# **PARACHUTES AUSTRALIA**

## **SERVICE BULLETIN No PA SB9302**

**SUBJECT:** S18 INSPECTION FOR SECURITY OF THE STIFFENER PLATE

**IDENTIFICATION:** Part No. S018-SOS-( ), all serial numbers  
Part No. S018-TAS-( ), all serial numbers

Stiffener Plate

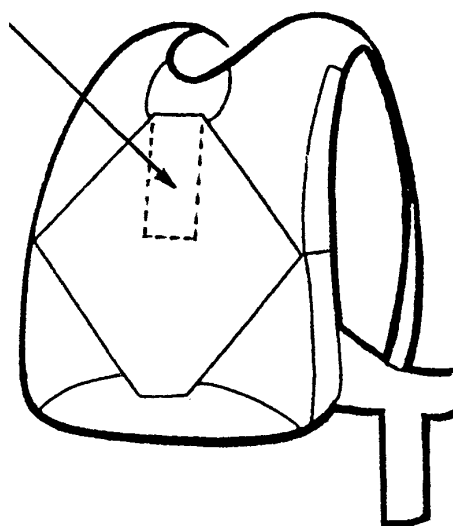
**BACKGROUND:** PA has received advice from the field that the mesh material which retains the reserve top metal stiffener in the reserve container had broken away and could affect the reserve deployment.

Prior to the next use, and thereafter at each scheduled reserve inspection, the security of the top flap stiffener plate shall be checked. If damage is evident the parachute shall be withdrawn from service until a satisfactory repair has been accomplished.
